BARANGAROO SOUTH

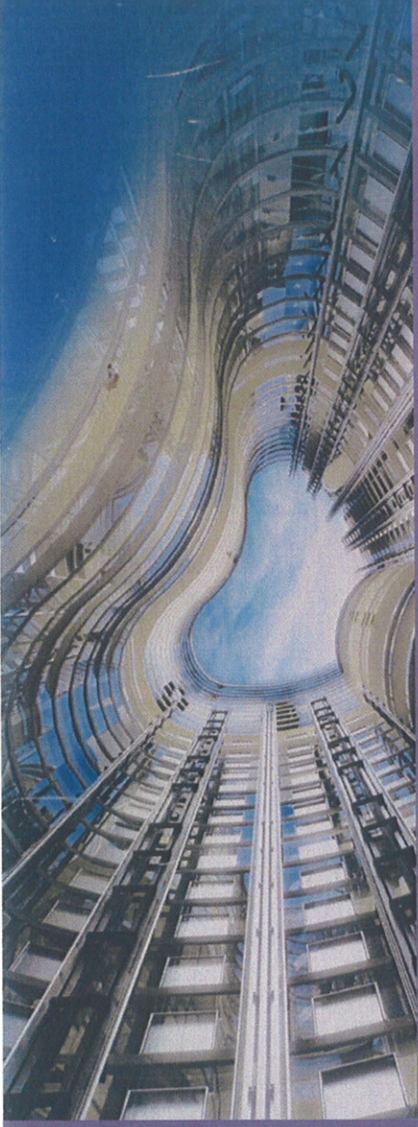
COMMENT ::

- 1.Sydney Opera House is sited on the NORTH END of point of land , and is low rise. VIEWPOINT .
- 2.Barangaroo HOTEL over Harbour does not have the picture taking spots at the entrance, like at Opera House. So maybe the RE-LOCATION of HOTEL .. May give better photo spots on land.
This seems to be an IMPORTANT issue for Mr Hutton.

- 3.Having ' CURVED SHAPES ' has been part of the appeal of Australia Square Tower, Aurora Tower, and Sydney Opera House. SO MAYBE THE ... OVAL SHAPE /s is consistent with that grouping of ICONIC Sydney buildings., instead of the BOXY shape of the current HOTEL PROPOSAL .

- 4.The MID + NORTH Barangaroo area COULD HAVE .. ICONIC gardens + buildings to view from a Hotel +
- 5.Other buildings on the South Barangaroo area. THSI WOULD BE a REPEAT of the ' iconic World Heritage Opera House View ' AT Circular Quay (East CBD) .
